No.	
Project No. Council Bill Associated Cases Staff Recommendation	Zone Change 2002Z-020T BL2002-1112; July 2, 2002 Council public hearing None.  Deferral. Staff has concerns about several issues related to the bill, including the definition of "recycling facility" and the lack of street standards for the proposed new use.
APPLICANT REQUEST	This council bill proposes to amend Sections 17.04.060 (Definitions of General Terms) and 17.16.110 of the Zoning Regulations to define and designate zoning districts for "Recycling facilities."
ANALYSIS	The primary intent of the legislation, as described by the sponsor, Councilmember David Briley, is to provide for one or more zoning district(s) within which a person or entity may operate a facility that separates construction waste in order to recycle appropriate materials, and within which a facility that handles common recyclable materials – such as aluminum and cardboard – may operate. Such operations currently are allowed under the Zoning Regulations only as "Waste Transfer" (17.16.210 C), which requires a minimum lot size of 10 acres, pre-approval of the site by the Metro Council, and approval of a special exception permit by the Board o

#### **Spring House**

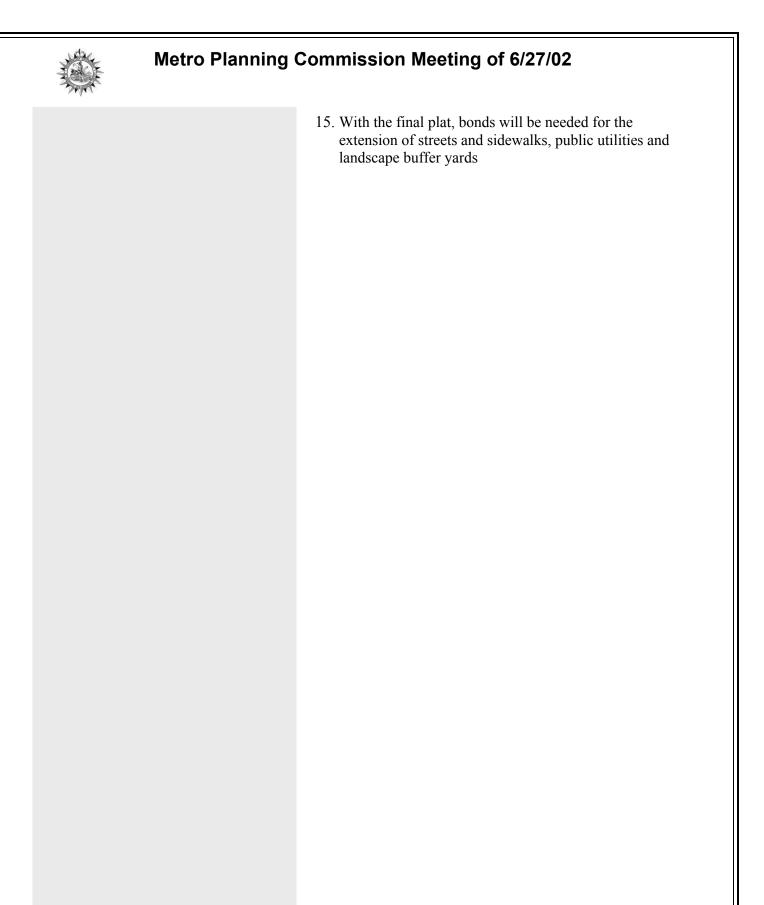
A natural spring is located in the vicinity of the Cane Springs Road/Springhouse Way intersection, adjacent to lot 27. This plat notes this spring is to be used as an amenity and preserved. However, no details have been presented at this time. There is great concern about this spring as it feeds a well and a pond on the adjacent neighbor's property (Mark W. and Carol A. Dugger).

Until more details have been presented about the spring's preservation and the treatment of the blue-line

stream, staff recommends that no grading, blasting or building construction permits be issued until after TDEC conducts its investigation and a final plat is recorded.
SUBDIVISION VARIANCES	None.
TRAFFIC ENGINEER'S FINDINGS	Metro Council conditioned this property's rezoning, to provide a left-turn lane on Cane Ridge Road between Blairfield Drive and the project entrance (Cane Springs Road). This improvement is near completion.  Cane Ridge Road is narrow and winding. It is not feasible for the developer to improve Cane Ridge Road between Bell Road and the property. Although the construction of 68 homes will impact Cane Ridge Road, there are large amounts of vacant land yet to be developed in the vicinity (Planning and Public Works staffs are continuing to review a method of proportional responsibility for road improvements). One intersection has been identified that will be greatly impacted by this subdivision, Preston Road and Cane Ridge Road. With the increased traffic from this development, there is concern for the safety of motorists at this intersection. As a condition of this approval, the developer needs to improve the sight lines along Cane Ridge Road in the northbound and southbound directions. This will involve lowering the profile of the hill located at the Cane Ridge Road/Preston Road intersection while maintaining good sight lines for vehicles exiting from Preston Road.
